ITEM 4. SECTION 96(2) APPLICATION: 286-296 SUSSEX STREET SYDNEY**FILE NO: D/2014/755/A****SECTION 96 APPLICATION NO: D/2014/755/A****SUMMARY**

Date of Submission:	25 November 2015
Amended Plans	11 May and 20 June 2016
Applicant:	Ausbao (286 Sussex) Pty Ltd c/o Urbis Pty Ltd
Architect:	Smart Design Studio
Developer:	Ausbao (286 Sussex) Pty Ltd
Owner:	Ausbao (286 Sussex) Pty Ltd
Cost of Works:	\$97,242,238

Proposal Summary: The subject Section 96(2) application seeks to modify the approved Stage 1, 80 metre building envelope for a mixed use development, accommodating hotel and residential land uses at 286-296 Sussex Street, Sydney. The application seeks to vary the maximum overall height of the tower to RL 91.300 (a maximum of approximately 83.25 metres) from the approved 80 metres. The application also proposes an additional basement level and modifications to the massing of approved floor plates from level 9 to roof level.

Figure 14: Northern (Druitt Lane) elevation of proposed modifications to approved Stage 1 envelope.

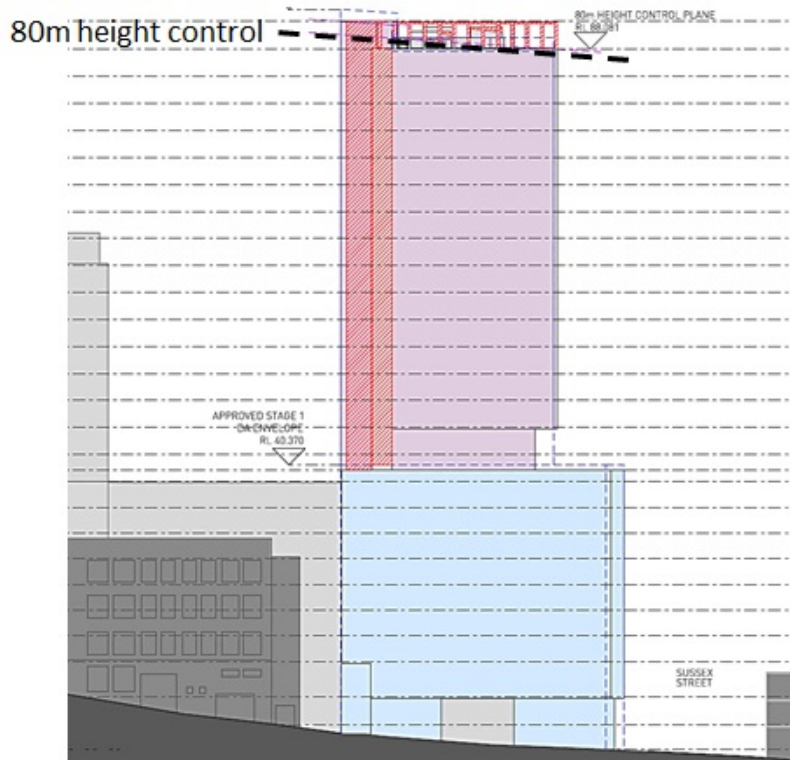
25. The Stage 1 building envelope was approved by the CSPC on 23 April 2015 with a maximum height of 80 metres.
26. Since the approval of the Stage 1 building envelope by the CSPC, the project has evolved as a result of:
- (a) a competitive design process held in mid-2015, with the Smart Design Studio scheme being named the winning design;
 - (b) detailed information now known on the design of lift overruns, and spatial requirements for plant and equipment to adequately service the building; and
 - (c) refinement of the architectural expression of the building, to provide an architectural roof feature being an upward projection of facade elements to screen those rooftop services.
27. Proposed modifications to the overall height of the approved Stage 1 building envelope are shown in **Figures 14 to 16** below.

- (a) the height of the development is appropriate to its site and context because:
 - (i) the site's sloping topography, which falls approximately 5.5 metres southeast to northwest, establishes a similarly sloping maximum height plane of 80 metres across the site pursuant to LEP clause 4.3;

- (ii) the detailed design of the building and of building services, has located the necessary plant and lift overrun so as to minimise any visual or other impacts and which protrude above the maximum 80 metre height plane and outside the previously approved Stage 1 envelope by between 120 and 600 millimetres;

- (iii) the detailed design incorporates an architectural roof feature being an upward projection of facade elements to screen the rooftop plant and equipment described above and to finish off the building;

Figure 17: Proposed modifications to floor plates – levels 9 to 10.

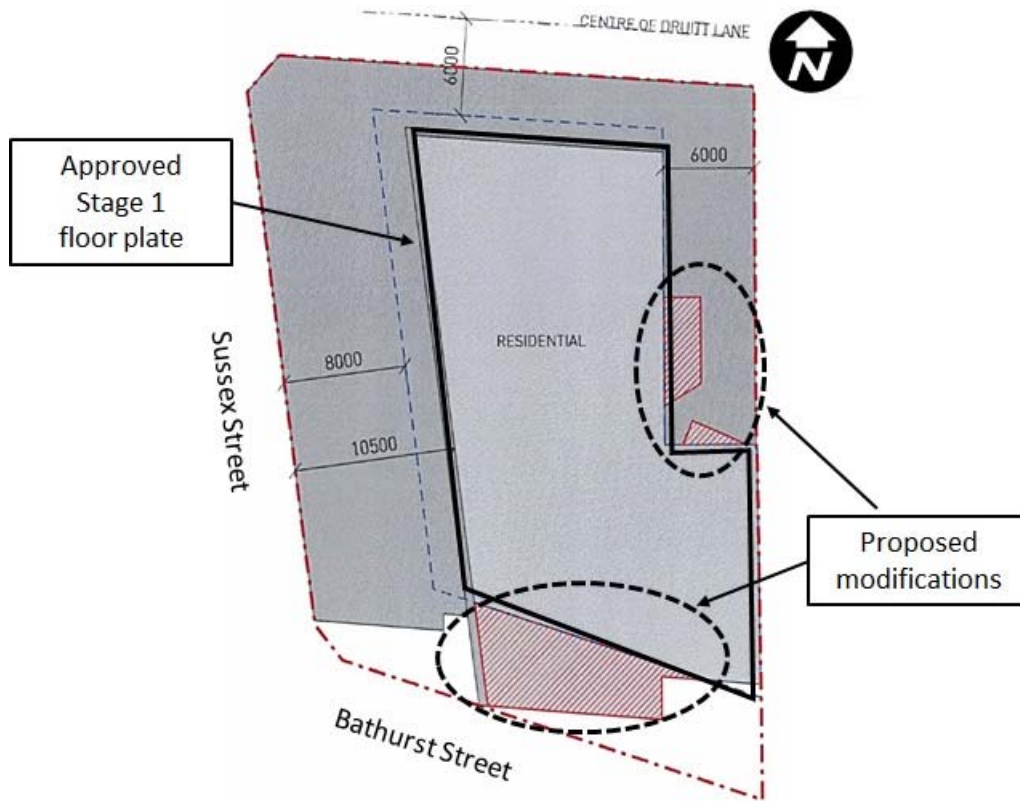
35. As shown in **Figure 17** above, the proposed modifications include an increase to the streetwall height to the Bathurst Street frontage by extending the floor plates of podium levels 9 and 10 to the property boundary with Bathurst Street. Provision 5.1.1(1) of the Sydney DCP 2012 (the DCP) requires a street frontage height of between 20 and 45 metres. This modification raises the Bathurst Street frontage height from 30 metres to about 34 metres, which still complies with the DCP street frontage height requirements.

Figure 18: Proposed modifications to floor plates – levels 11 to 24.

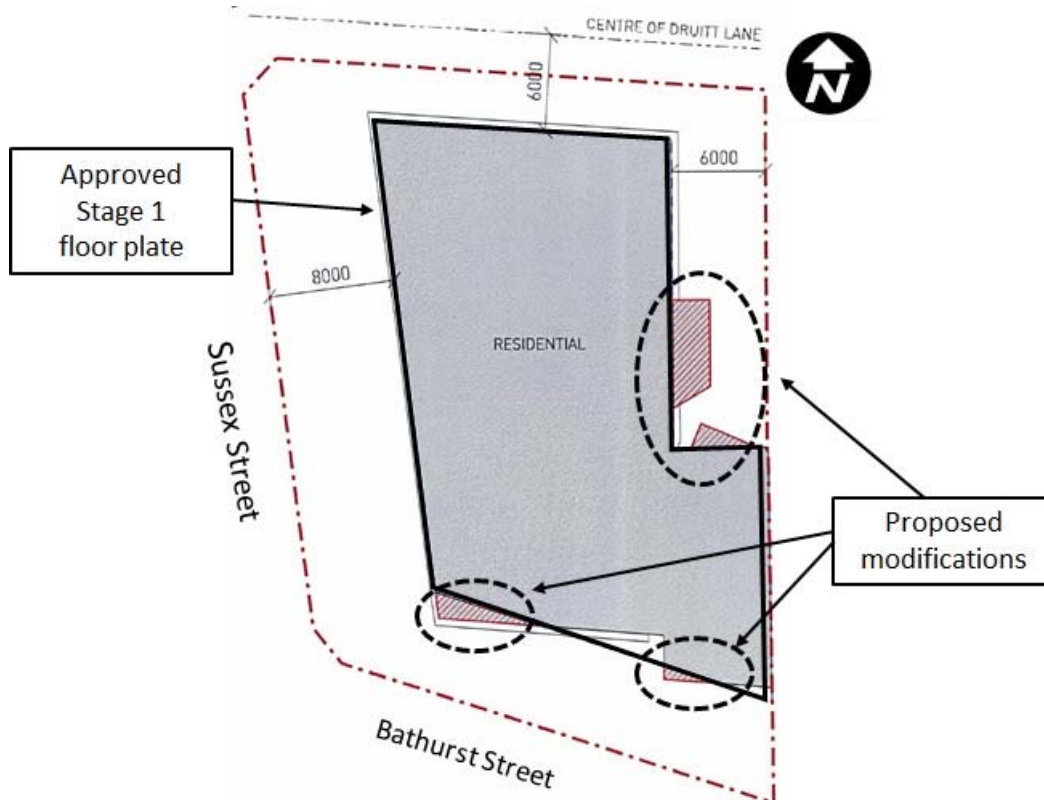
36. DCP provision 5.1.2.1(1) requires a minimum 6 metre setback above street frontage height to Bathurst Street. As shown in **Figures 18 to 21** above, the proposed modifications to the floor plates of tower levels 11 to roof level, encroach upon this minimum 6 metre setback providing a minimum setback of 4.5 metres from the property boundary with Bathurst Street at the tower's south-western corner.

39. Level 14 of the proposed tower on the eastern side of the building is at a height of about 45 metres. As shown in **Figures 17 to 21** above, on each floor from Level 14 to the uppermost floor (Level 25), the proposed modification reduces setbacks on the eastern side and at the south-eastern corner of the floor plate and which encroach upon the minimum 6 metre setback zone to the eastern boundary.

Figure 22: Diagram in elevation showing shadowing of the residential tower at 298-304 Sussex Street at 11am on 21 June.

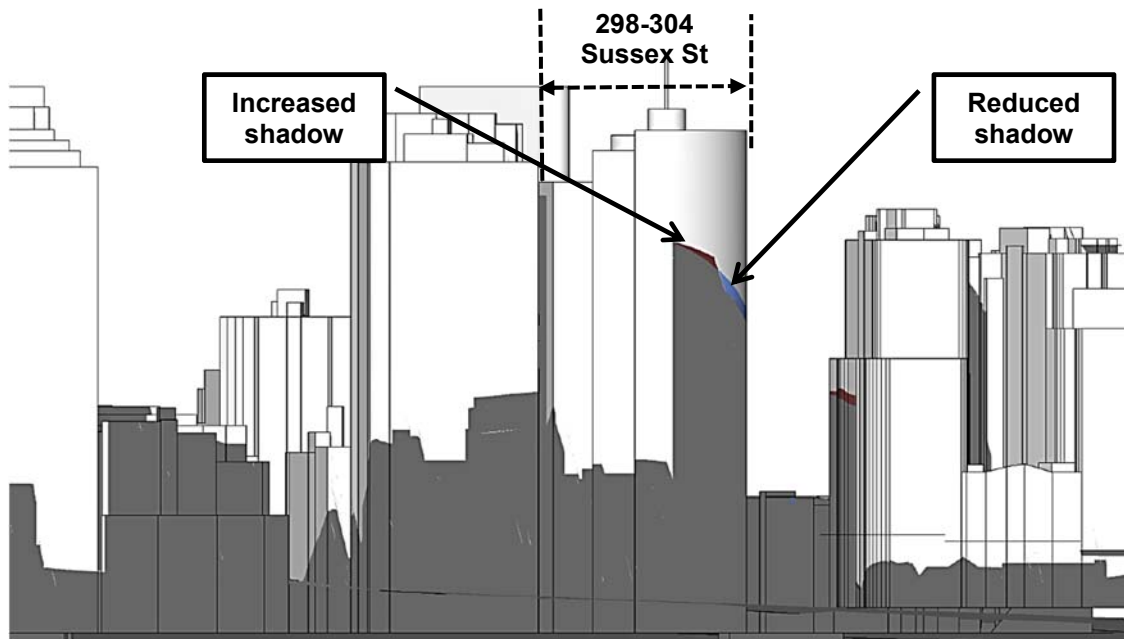
45. The submitted shadow diagrams at Attachment C to this report, an extract of which is shown in **Figure 22** below, demonstrate that the proposed changes to the building envelope and subsequent breaches of the maximum building height result in negligible net change to overshadowing of the windows of the residential building to the south at 298-304 Sussex Street.

Figure 23: Diagram in elevation illustrating shadowing of the residential tower at 158-166 Day Street at 10am on 21 June.

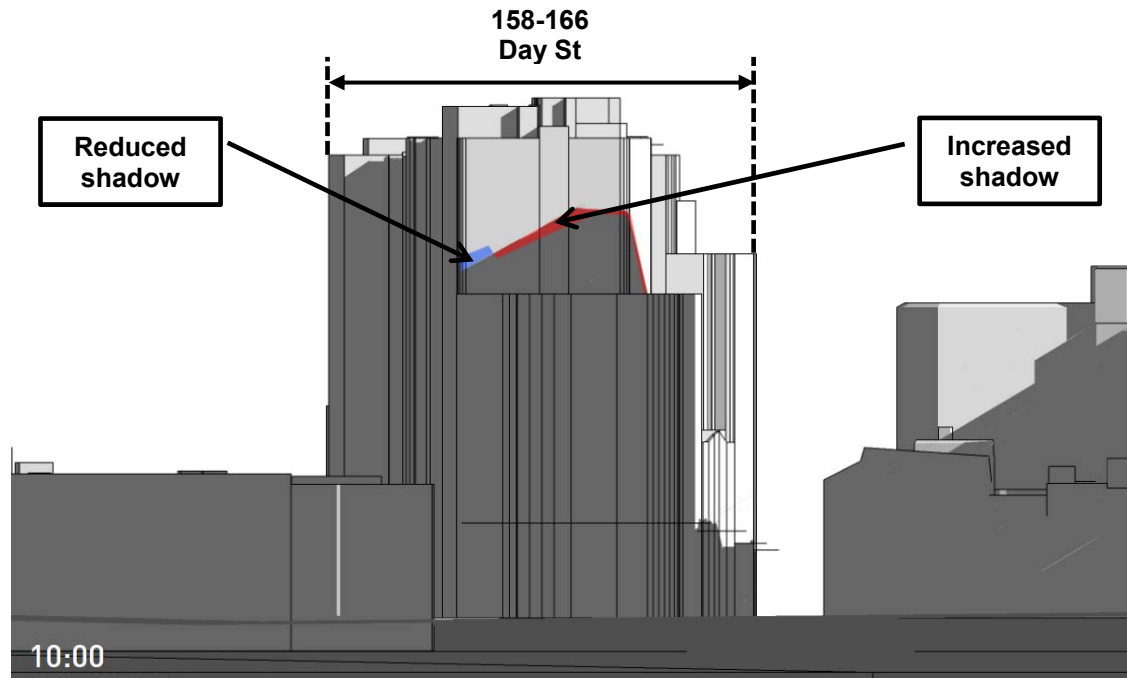
46. The submitted shadow diagrams at Attachment C to this report, an extract of which is shown in **Figure 23** below, demonstrate that the proposed changes to the building envelope result in negligible net change to overshadowing of the windows of the residential building to the south at 158-166 Day Street.

47. Given that the proposal provides an otherwise compliant development in terms of FSR, street frontage height, and setbacks above street frontage height, the negligible net overshadowing impacts are considered to be minimal and are acceptable in the dense urban context of the CBD.
